## **Manual Bituminous Patching On Borough Streets (Addendum #1)**

**I have received the Addendum #1 for the Proposal, Specifications, and Contract for Manual Bituminous Patching on Borough Streets**

## SUPERPAVE RESTORATION DETAIL

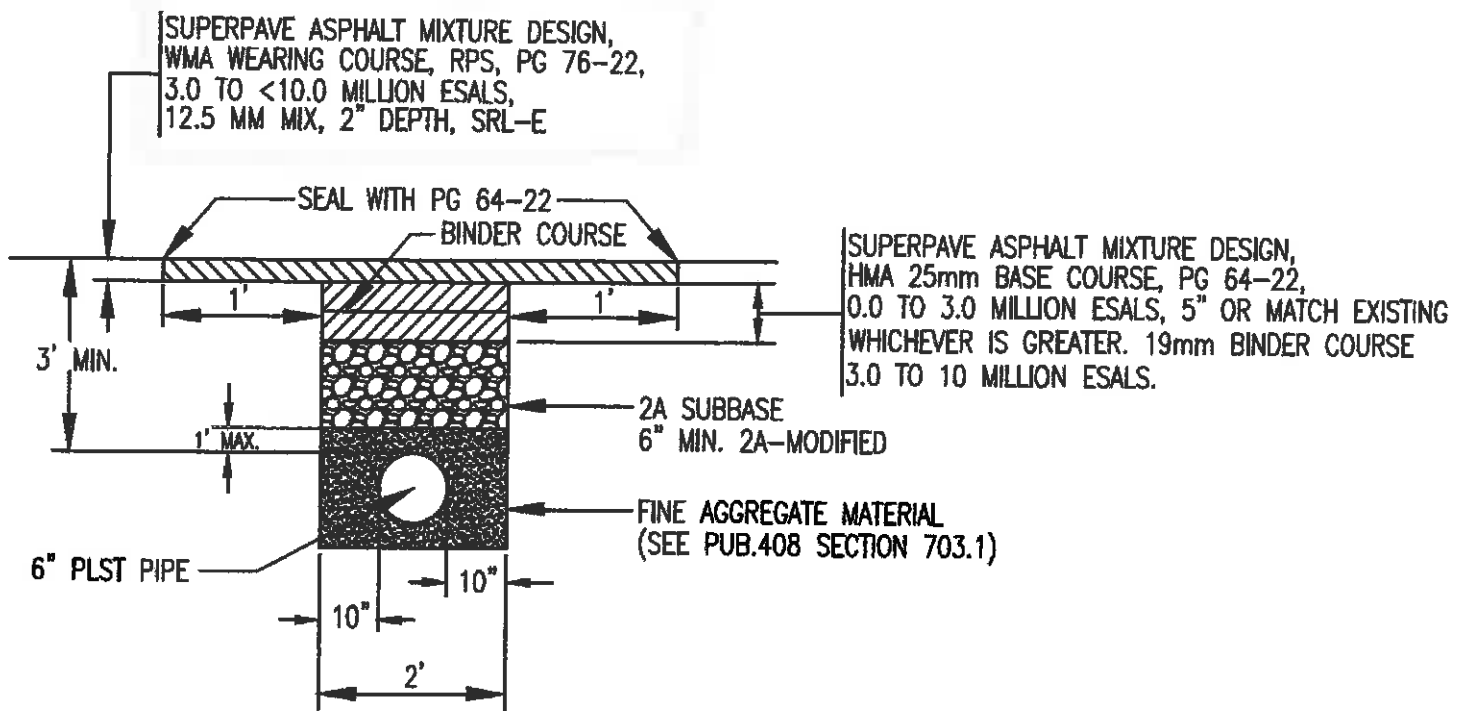
1. At the pre-bid meeting, staff discussed a patching project for the Gas Department on a State Route that would have involved a different Superpave Asphalt Mixture Design than what was included on the MS-944 (see attached plan sheet). This project **will not** be included in this bidding process.
